# BURK-KLEINPETER, INC.

November 22, 2016

RE: Disposition of Comments from Request for Review of Application  
Dredging Improvements to Biloxi Waters  
DMR-060766 (Canaan Fishing Pier)  
DMR-060768 (Point Cadet Marina)  
DMR-140114 (Goose Point)  
DMR-140200 (Hiller Park Boat Ramp)  
DMR-170041 (Mercedes Drive)  
DMR-170043 (Holly Hills)  
DMR-170044 (Sunrise)

RE: Disposition of Comments from Request for Review of Application  
Dredging Improvements to Biloxi Waters  
DMR-140114 (Goose Point)  
DMR-170043 (Holly Hills)  
DMR-170044 (Sunrise)

## SITE G - SUNRISE

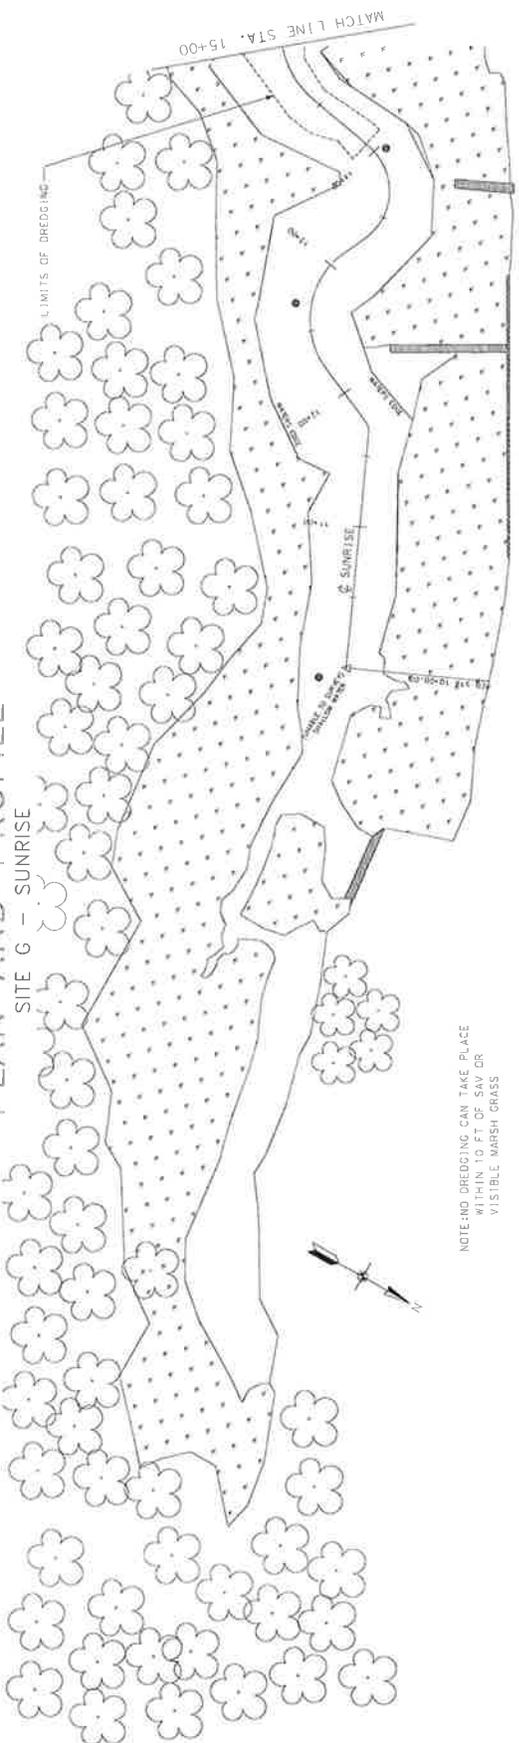
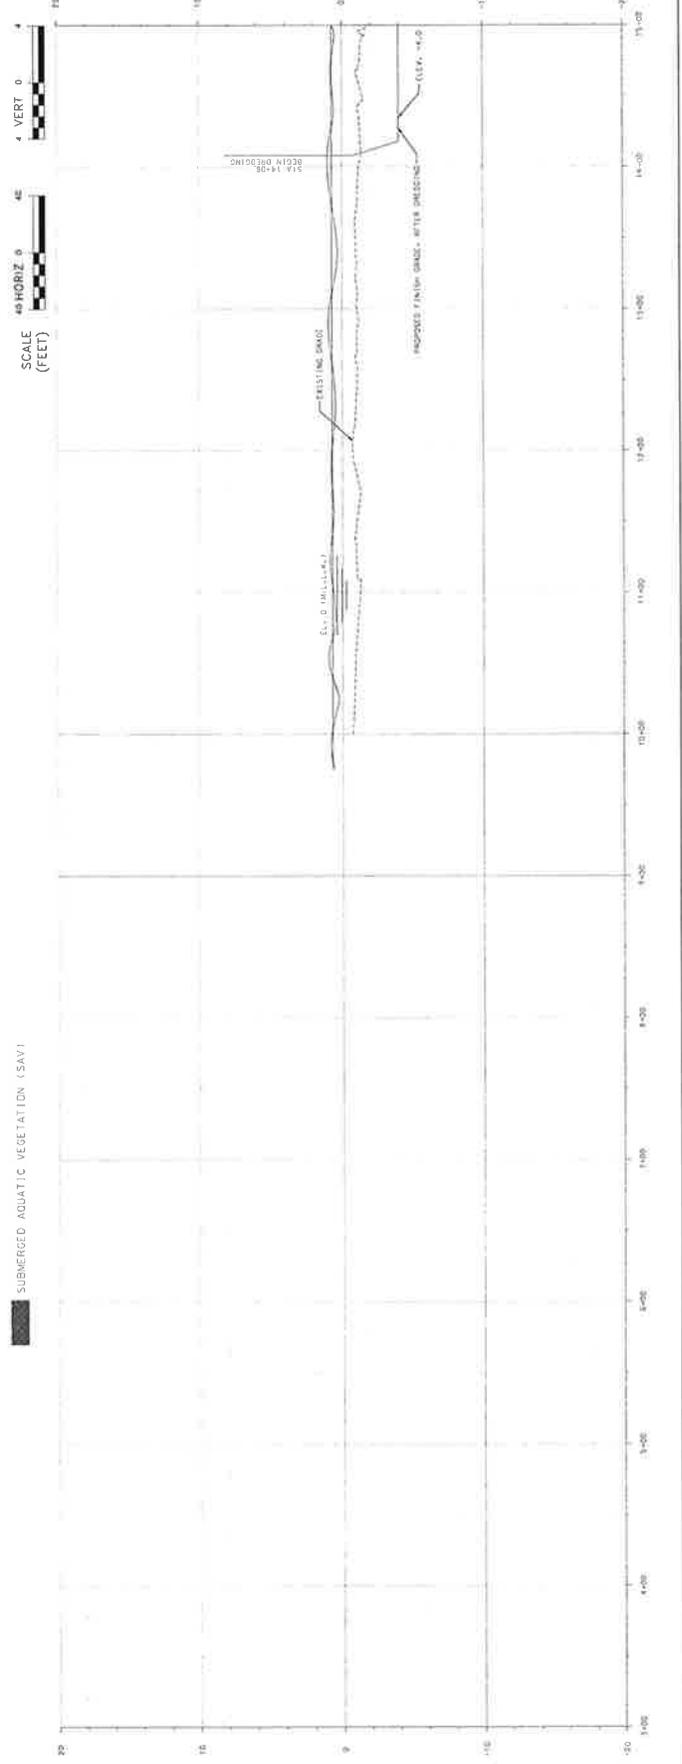
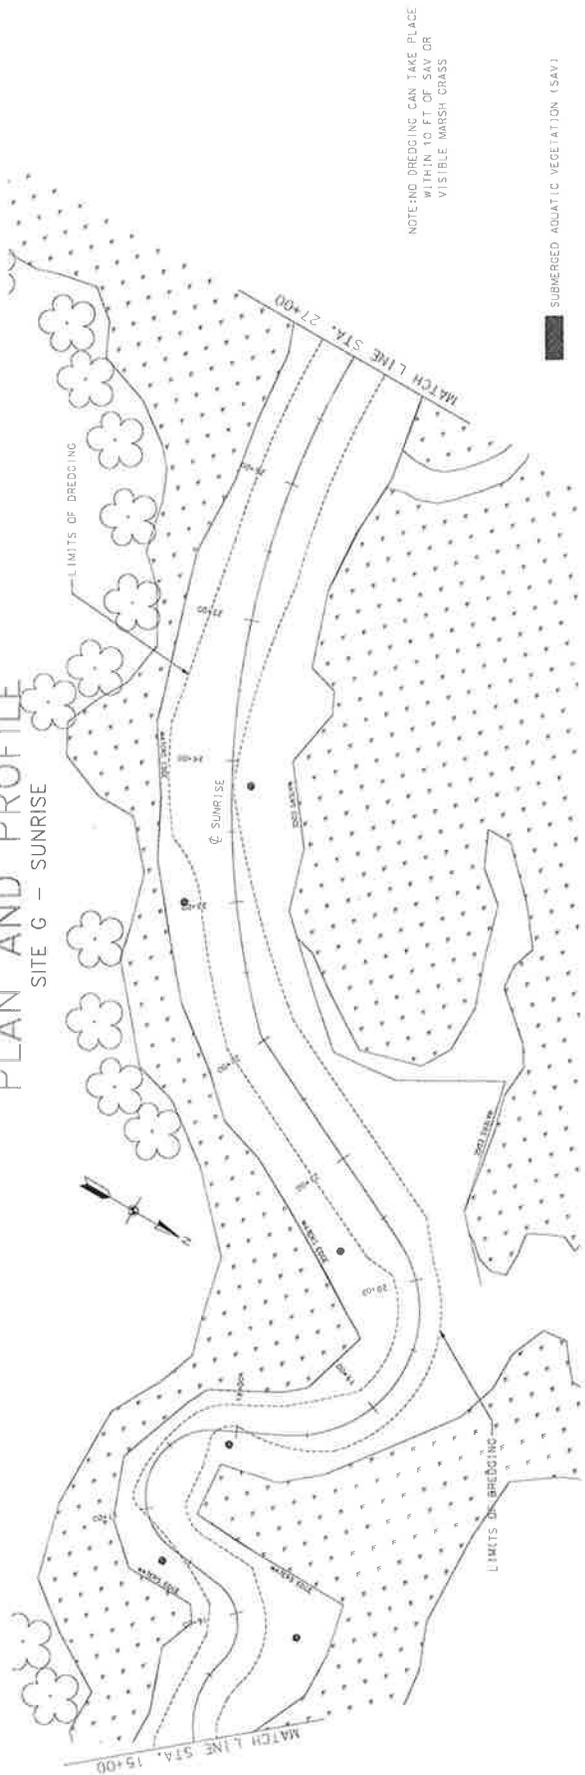
1. *I am writing this because I object to dredging project at the Sunrise site. I do not object to the dredging as a whole but with the stopping point. if you stop at proposed stopping point just as many homes will receive "0" benefit as those that will receive significant benefits. I have been told that the current stopping point is because of marsh grass. If you look at historical satellite images you can see the marsh grass has been removed in this area previously. I have lived here for over 30 years. The canal behind my house was here before I moved into my home. I was told then it was for street drainage. The area I am talking about is just to the west of canal. The marsh grass was removed by current home owner. They will benefit from this directly.*

*We are talking about maybe 50'. Casinos have destroyed more than this easily. There must be a way to get this done in fairness to the residents east of the current proposed stopping point.*

*Please reconsider stopping point to include all residents. That is the fair thing to do.*

G. Based on the information provided by Barry A. Vittor & Associates, there is submerged aquatic vegetation located within our project limits. Please see the attached revised plan and profile of the project limits. The modifications stopped the dredging approximately 400 FT from the original end and reduced the estimated quantities by approximately 850 C.Y.
